Service Campaign Bulletin

Mercedes-Benz

Campaign No. 2015040005, May 2015

SUBJECT: **Model 205, Model Year 2015**
Install Spacer Ring at Coolant Line

**Figure 1**

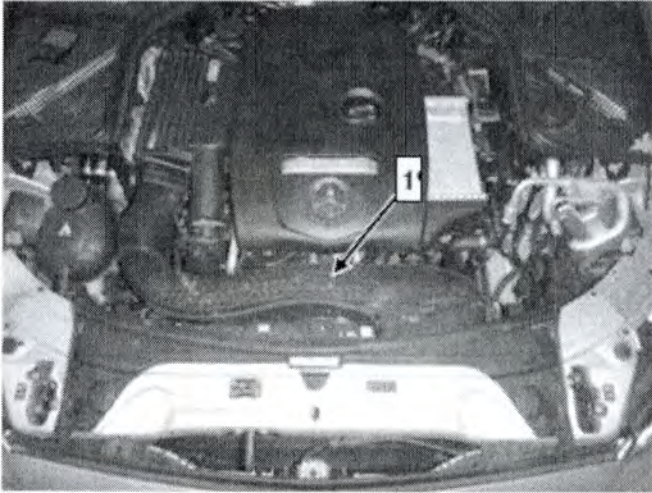
1.  Remove engine air intake duct (1, Figure 1) upstream of air filter.

**Figure 2**

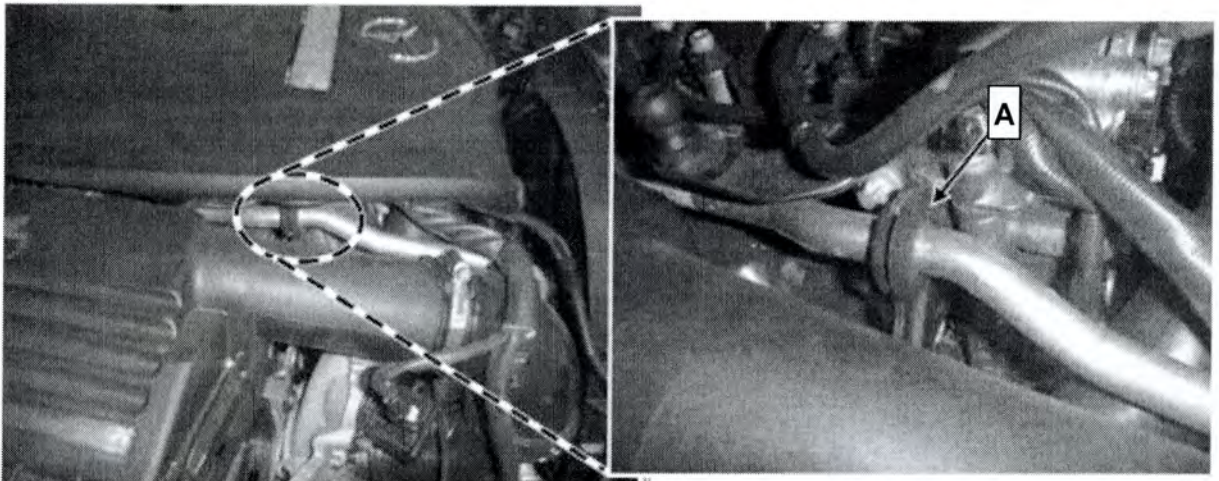
2.  Press rubber grommet (A, Figure 2) out of bracket.

3.  Install spacer ring (B, Figure 2) on metal coolant line.
 The lock of the spacer ring (B) should point in the direction of travel (towards the front).

Figure 3

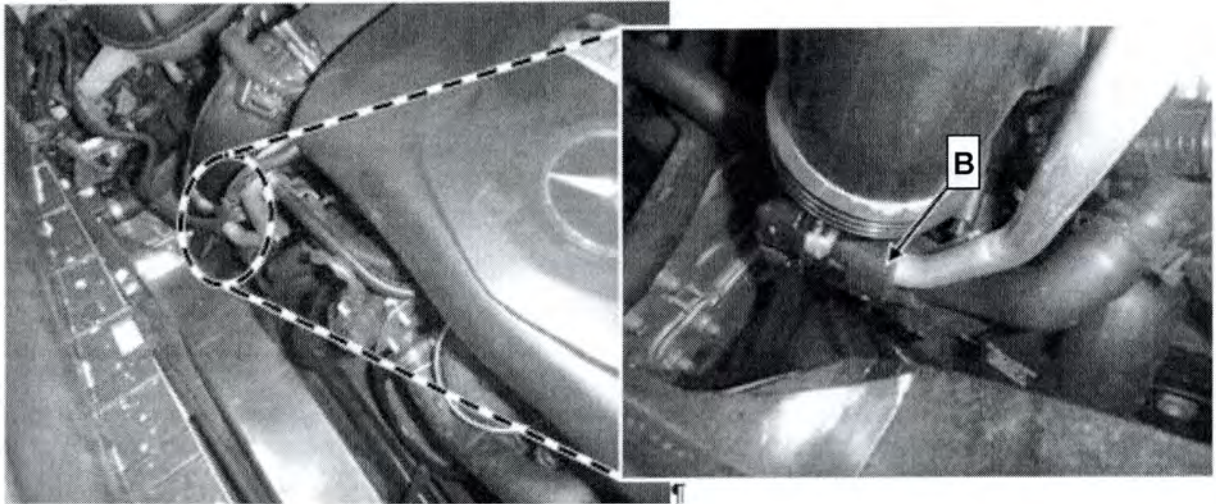
4.  Press rubber grommet (A, Figure 2) back into bracket again.
 The rubber grommet (A) must be seated correctly in the bracket.
5. Reassemble in reverse order.
